Access Compliance Report

Public Rights-of-Way

(Pedestrian Signals)

Intersection ID: N/A	Main Street:	Cross Street: N/A	Location: N/A
ADA ID: CD65A51CB48C	Signal Type: One Push Button-Non APS	Overall Compliance: No	Severity Score: BTN 1: N/A BTN 2: N/A No BTN: N/A
Codes/Mitigation Info/Possible Solution		Field Measurements/Component Compliance

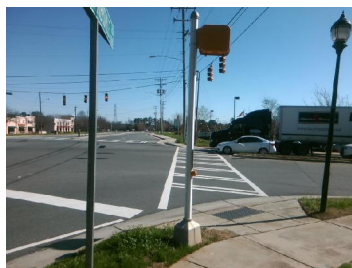
PROW/ADA: R404.2, R404.7.2

N/A	B 1 FWD Approach Width (in)	N/A	N/A	B 2 FWD Approach Width (in)	N/A
N/A	B 1 FWD Approach Obstruction?	Yes	N/A	B 2 FWD Approach Obstruction?	N/A
N/A	B 1 FWD Approach Obstruction Dist (in)	3.0	N/A	B 2 FWD Approach ObstructionDist (in)	N/A
N/A	B 1 PARA Approach?	Yes	N/A	B 2 PARA Approach?	N/A
N/A	B 1 PARA Approach Constrained?	Yes	N/A	B 2 PARA Approach Constrained?	N/A
Yes	B 1 PARA Approach Reach (in)	6.0	N/A	B 2 PARA Approach Reach (in)	N/A
No	B 1 PARA Approach Width (in)	48.0	N/A	B 2 PARA Approach Width (in)	N/A
N/A	B 1 PARA Approach Obstruction?	Yes	N/A	B 2 PARA Approach Obstruction?	N/A
N/A	B 1 PARA Approach Obstruction Dist (in)	3.0	N/A	B 2 PARA Approach ObstructionDist (in)	N/A
Yes	B 1 Clear Floor Space Slope (%)	0.7	N/A	B 2 Clear Floor Space Slope (%)	N/A
No	B 1 Clear Floor Space XSlope (%)	5.0	N/A	B 2 Clear Floor Space XSlope (%)	N/A
N/A	B 1 PAR Slope (%)	N/A	N/A	B 2 PAR Slope (%)	N/A
Yes	B 1 Height (in)	42.0	N/A	B 2 Height (in)	N/A

Possible Solutions: Remove and Replace Clear Space.
